ADA Curb Ramp New Construction Inspection Form (Parallel)

Nw 314th ave

24952.54

Nw. Kaybern st

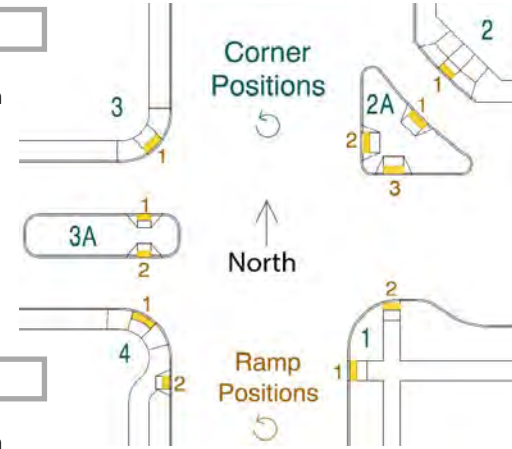
No truncated dome, no RR2 or RR3
